Jordan Springs East Stage 3B2

Road Safety Audit - Concept Design

SEPTEMBER 2017

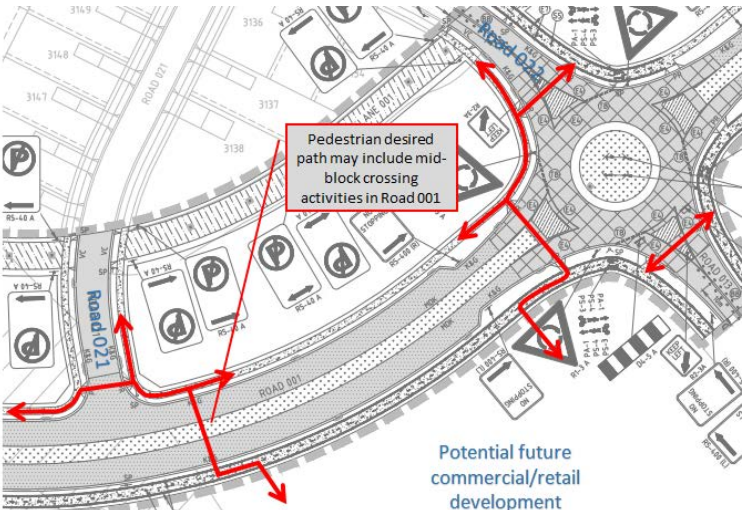
No	Drawings/Location/ Road safety category	Description of findings	Why this is a safety concern	Risk rating (severity/frequency)	Designer's response (12/09/2017)
1	CV-CARDNO-ST03B2-1701 Pedestrians	<p>A pedestrian desire walking line is likely to exist to and from the commercial/retail development proposed south-west of Road 001 and Road 013, which may include mid-block crossing activities in Road 001 between Road 021 and Road 022. No formalised pedestrian crossing facility has been proposed to manage the potential crossing activities mid-block in Road 001.</p> 	Increased likelihood of vehicle/pedestrian crash along Road 001 due to non-provision of formalised pedestrian crossing facility to service the pedestrian crossing demand generated by the proposed commercial/ retail development south-west of Road 001 and Road 013.	High (Serious/ Occasional)	<p><i>Pedestrian crossing points are located east and west of the site at the proposed roundabouts. It is expected that most pedestrians north of Road 001 will navigate to the retail development via Road 002 and Road 022 and utilise these crossings. Constructing a crossing at the midpoint of the two proposed roundabouts may be a hazard in itself as pedestrians may be hidden by the proposed landscaped median. We propose to maintain the current design unless instructed otherwise by council.</i></p>

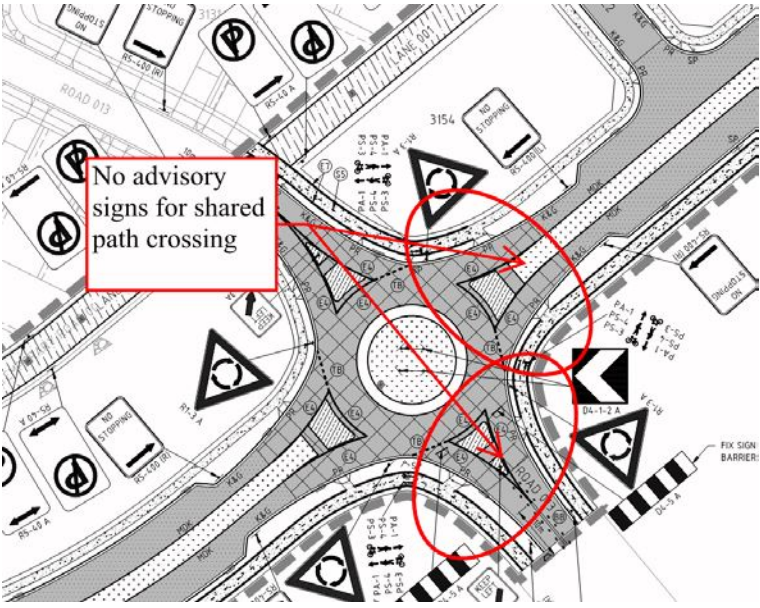
No	Drawings/Location/ Road safety category	Description of findings	Why this is a safety concern	Risk rating (severity/ frequency)	Designer's response (12/09/2017)
2	CV-CARDNO-ST03B2-1701 Pedestrians and Cyclists	<p>The shared path crosses the roundabout at the intersection of Road013 and Road001 on the south and west approach. There is no warning signage proposed for vehicles approaching the roundabout to watch for cyclists or for cyclists on the shared path to yield to/watch for vehicles.</p> 	Increase likelihood of a crash due to lack of awareness by motorists of bicycle crossing activities at the shared path, or if cyclists are unaware of the priority at the crossing.	High (Serious/ Occasional)	<p>Signage at the proposed roundabout is consistent with previously designed roundabouts in the estate and additional signage may overcomplicate and distract motorists.</p> <p>We propose to maintain the current design unless instructed otherwise by council.</p>

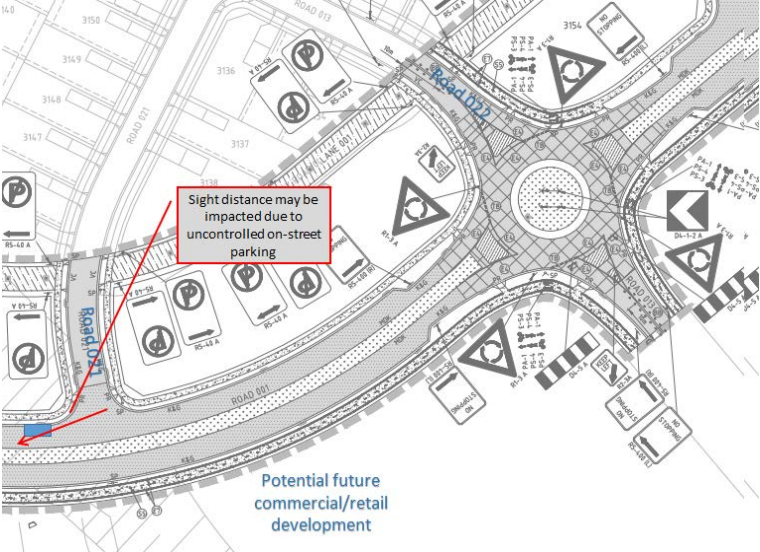
No	Drawings/Location/ Road safety category	Description of findings	Why this is a safety concern	Risk rating (severity/ frequency)	Designer's response (12/09/2017)
3	CV-CARDNO-ST03B2-1701 Parking	<p>There is an indented parking bay to allow for kerbside parking along Road 001 between Road 021 and Road 022. Moderate to high future parking demand is expected in the indented parking bay due to the commercial/retail land uses proposed within its immediate vicinity.</p> <p>There is a lack of on-street parking restriction proposed in Road 001 to ensure on-street parking compliance and ascertain adequate sight distance for vehicles exiting from Road 021 to Road 001.</p> 	If parking is close to an intersection driver sight lines will be impacted leading to an increased crash risk.	Low (Limited/ Occasional)	<i>No stopping signage will be incorporated to provide adequate sight distance</i>

Client: LENDLEASE
Project: JORDAN SPRINGS EAST
STAGE 3B2 - CIVIL WORKS
DRAFT DEVELOPMENT APPLICATION
Title: TYPICAL ROAD CROSS SECTIONS

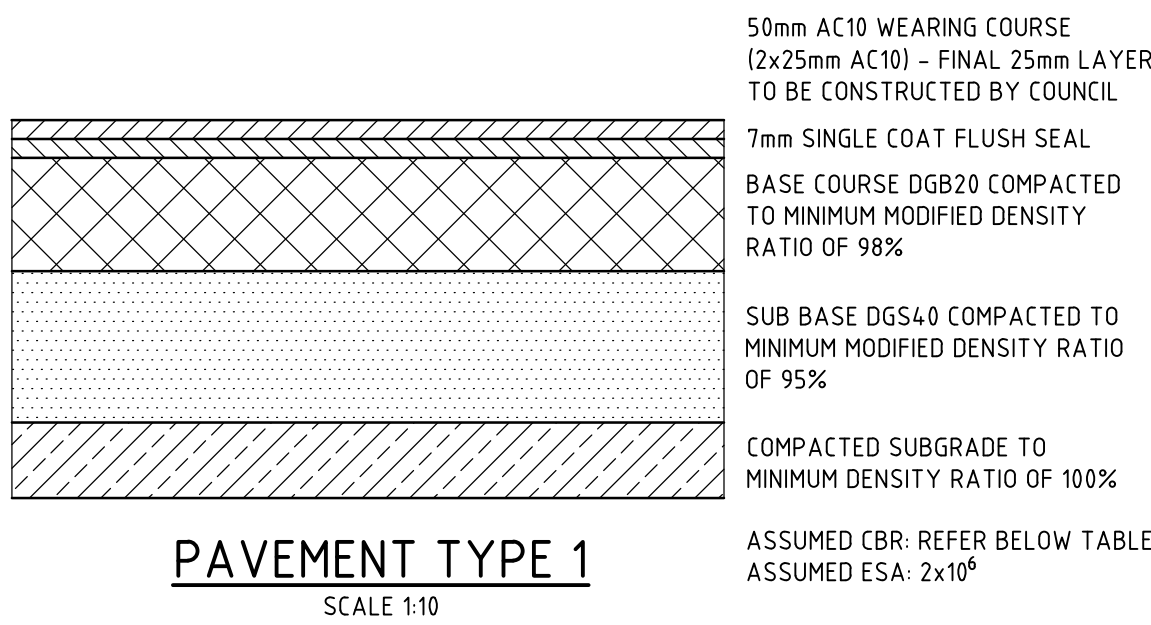
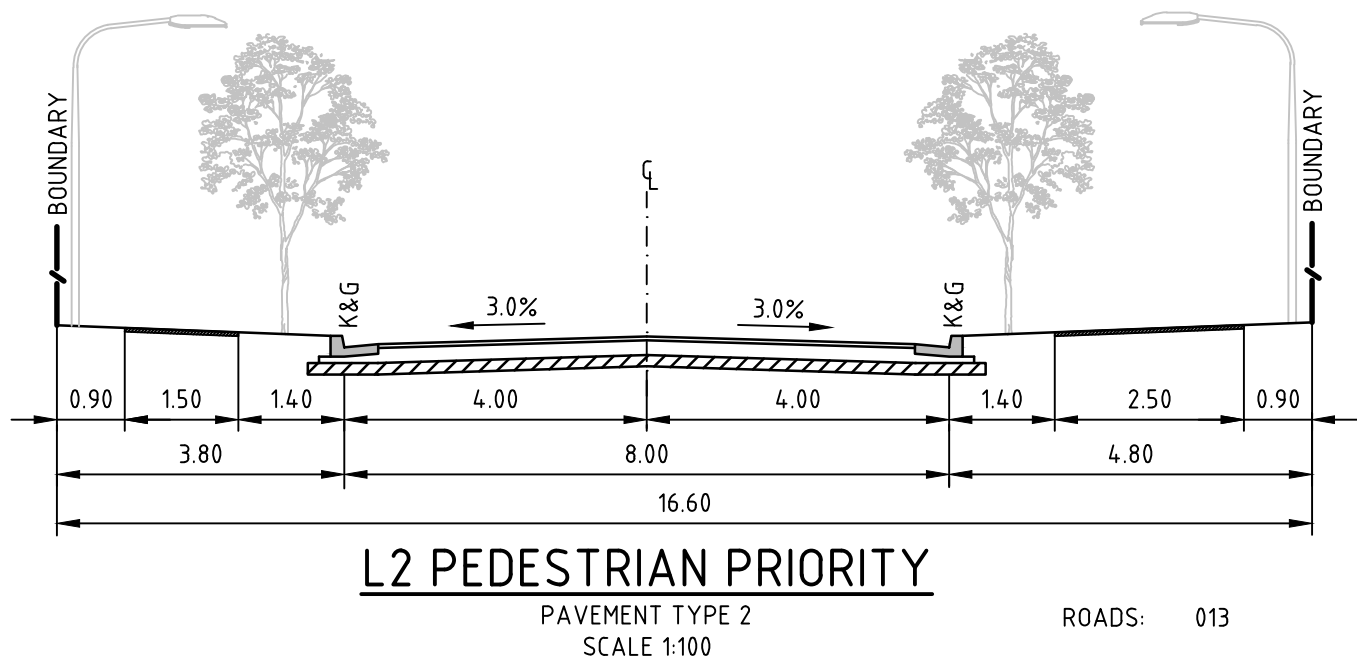
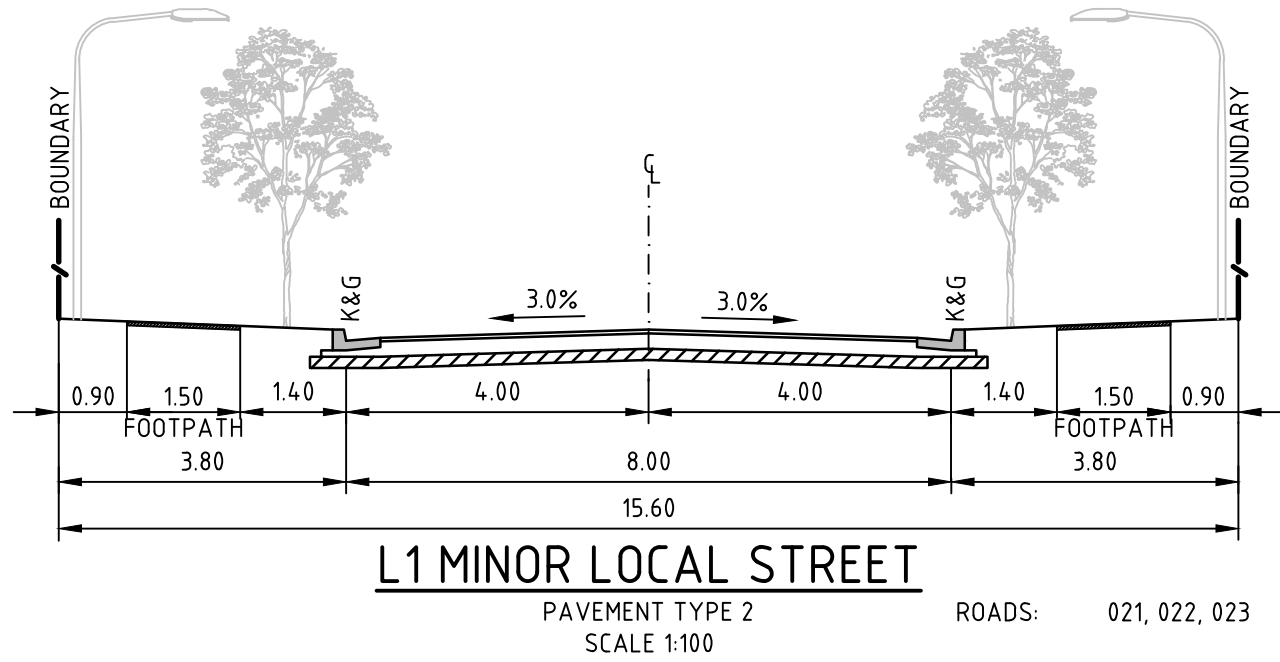
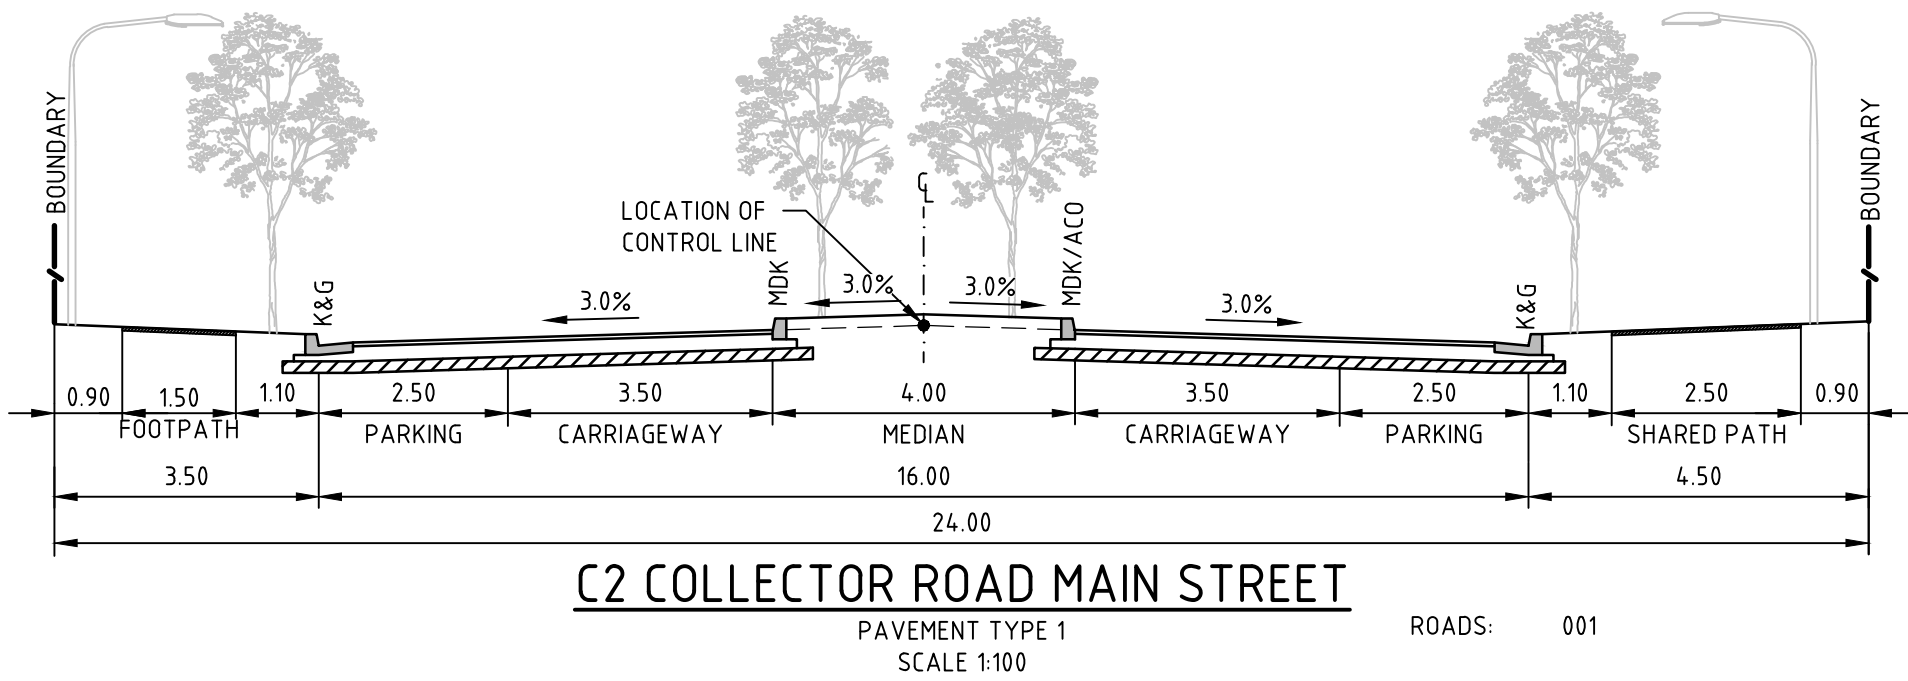
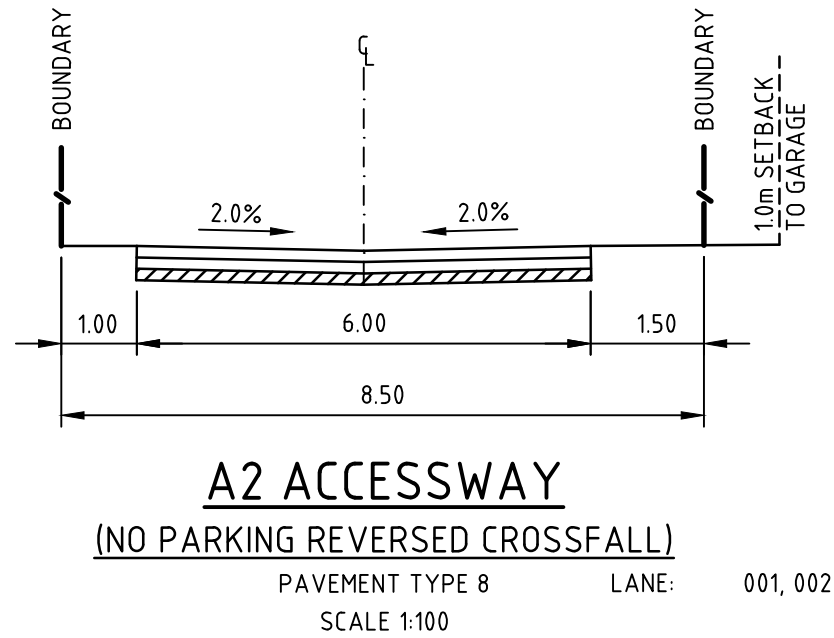
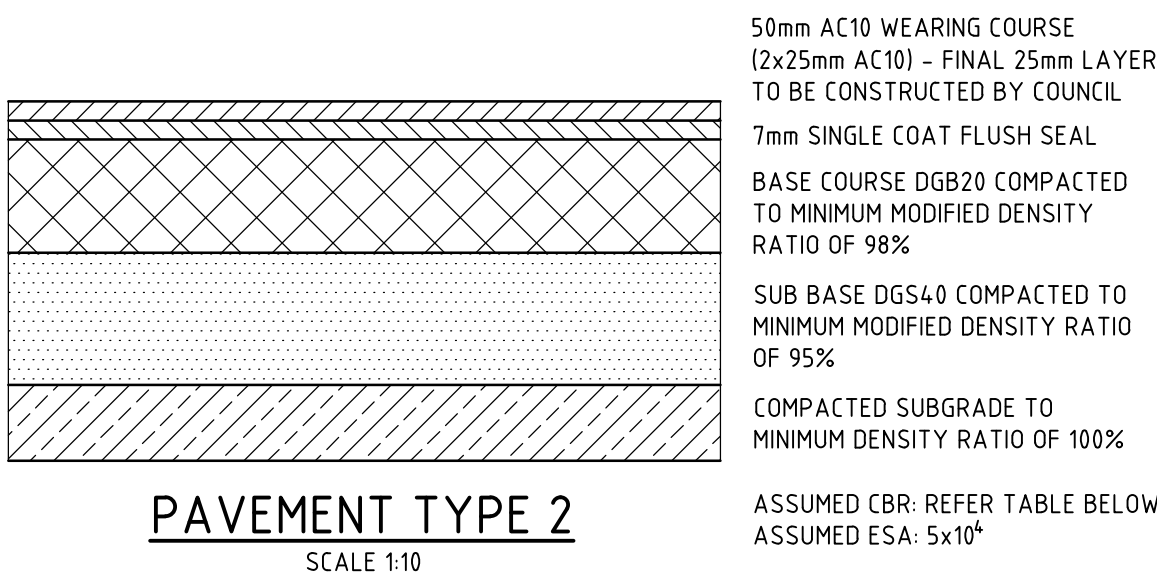
No	Drawings/Location/ Road safety category	Description of findings	Why this is a safety concern	Risk rating (severity/ frequency)	Designer's response (12/09/2017)
NOTE 1	General Comment Pavement	Pavement design shown in the detailed design drawings indicate an assumed California Bearing Ratio (CBR) of 3% and 5%. Ensure confidence in CBR prior to construction as insufficient pavement thickness leads to pavement defects including potholes which may lead to an increased crash risk (for example swerving late to avoid defect).		Note only	
NOTE 2	Lighting	No lighting plan or assessment provided.	Adequate lighting particularly at any designated pedestrian crossing points and intersections has the potential to reduce crash risk.	Note only
